PSU Supplemental

PSU-2 Original Design

PSU-2 New Design

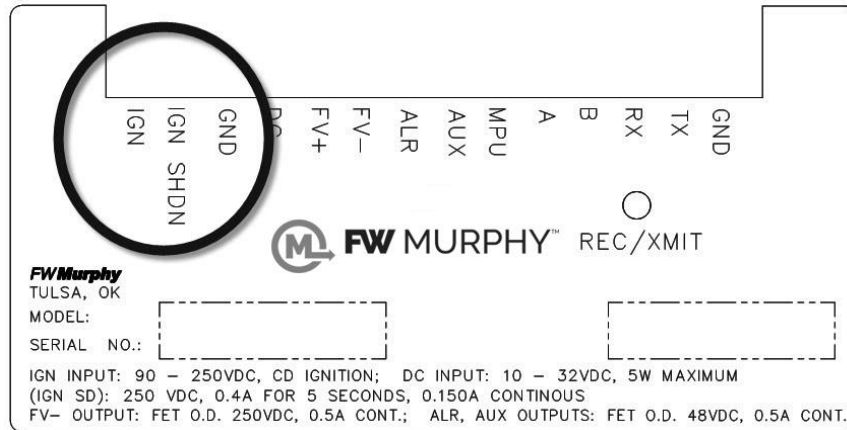
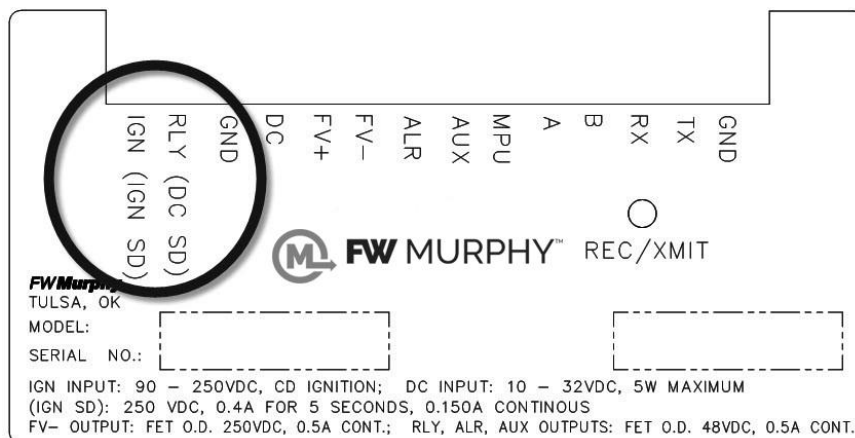
- If the PSU-2 matching the above referenced image, is being replaced by the below referenced image, **please see the reversed side of this document for wiring the new PSU-2.**

- **Setup A menu has changed.** With the change in design of the new PSU, the result is an additional output can be configured for additional application functionality. Please use IOM# 00-02-0697 for the setup configuration.

OLD

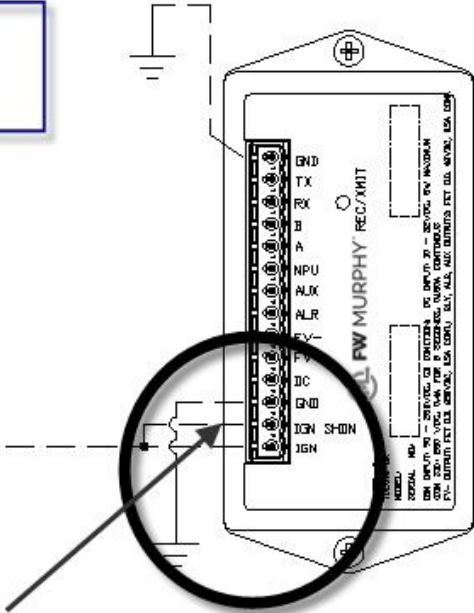
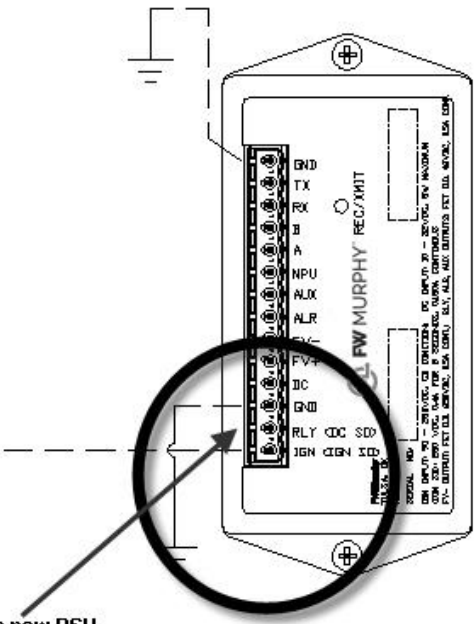
Jumper used to provide Ignition (G-Lead) grounding for shutdown

Remove jumper with new PSU design. Ignition (G-Lead) grounding for shutdown is provided on single input
